**SUSITNA  
HYDROELECTRIC PROJECT**  
(PROJECT NO. 7114-000)

RESPONSES TO  
THE DEPARTMENT OF THE INTERIOR  
COMMENTS ON LICENSE APPLICATION

February 15, 1984

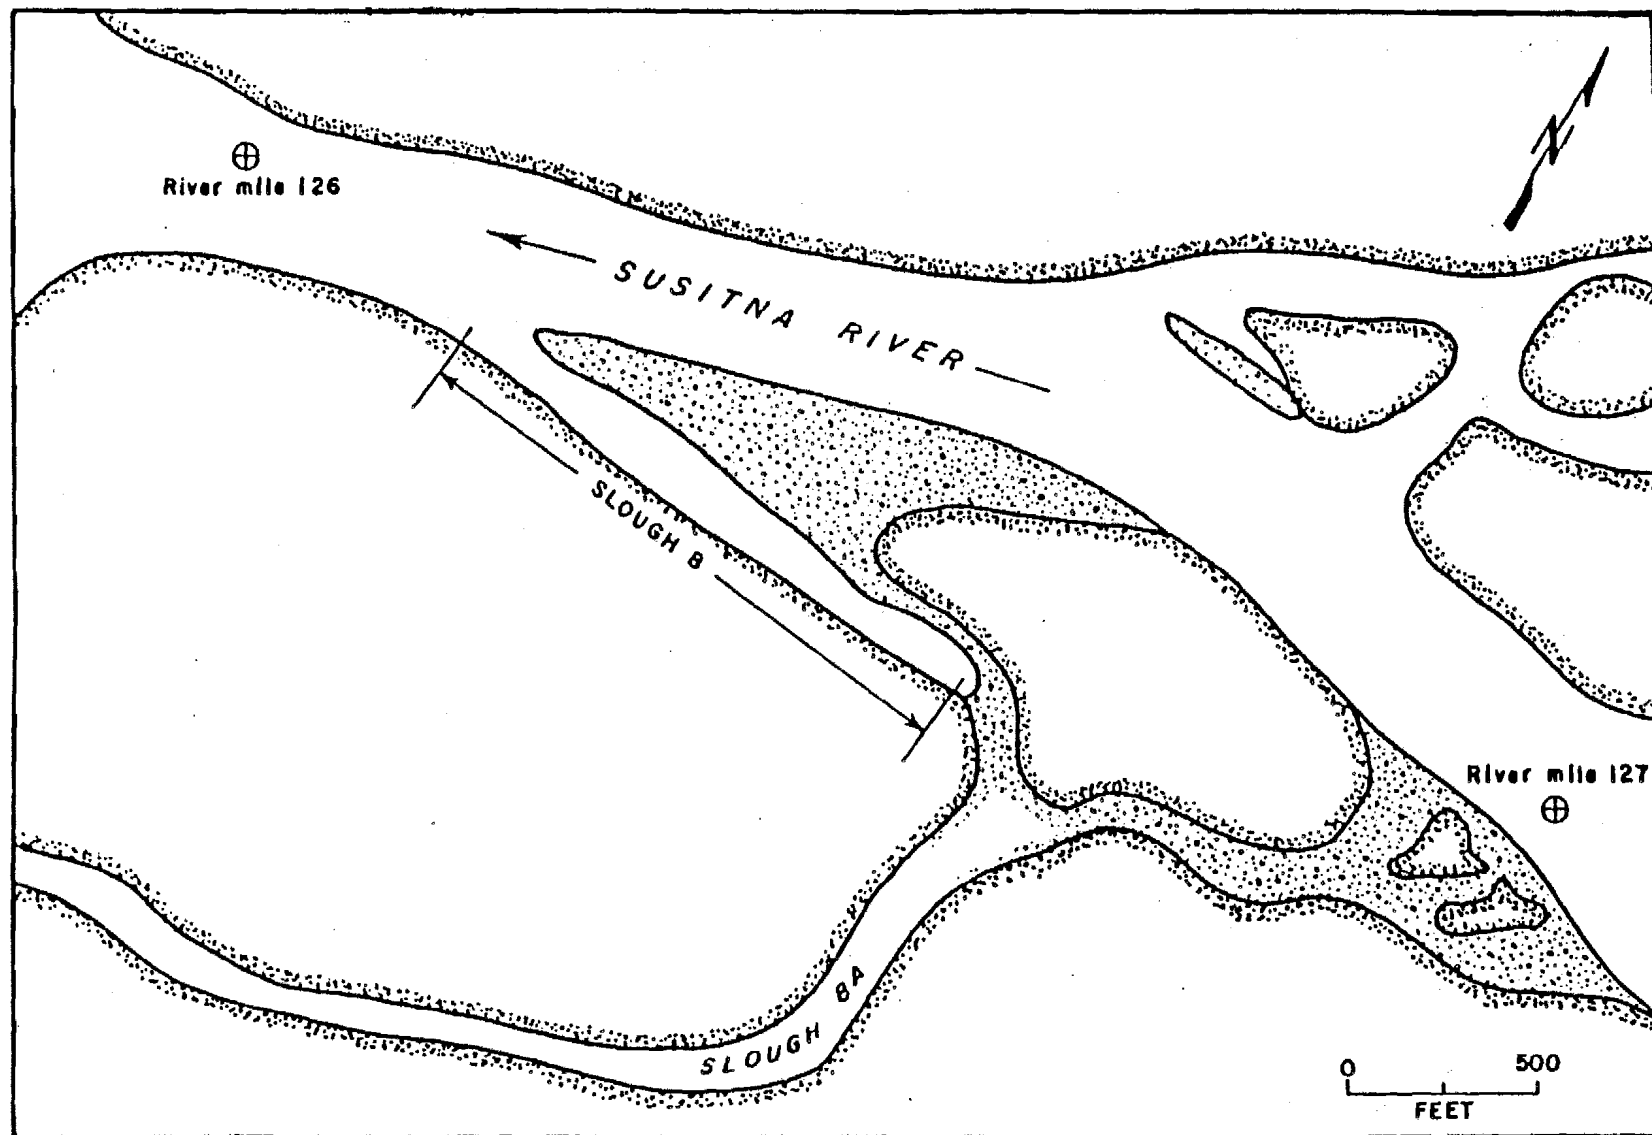
Any given slough would need a predicted overtopping frequency of more than once every five years to be protected.

As the flow release schedules are refined through additional study and the negotiation process, the need for upstream berms will be reexamined.

The purpose of the protective berms is to prevent overtopping of the upstream end of the slough. This prevents mainstem water from entering the slough. Therefore, the discharge from the slough originates primarily from groundwater during the ice-covered season. (With a protective berm in place, additional flow to the slough can originate from local sources such as runoff.) Because this groundwater is warmer than 0°C, the ice that may form is not of the magnitude that is found in the mainstem (up to several feet thick). Water would still be expected to flow out of the slough and fish would be expected to outmigrate.
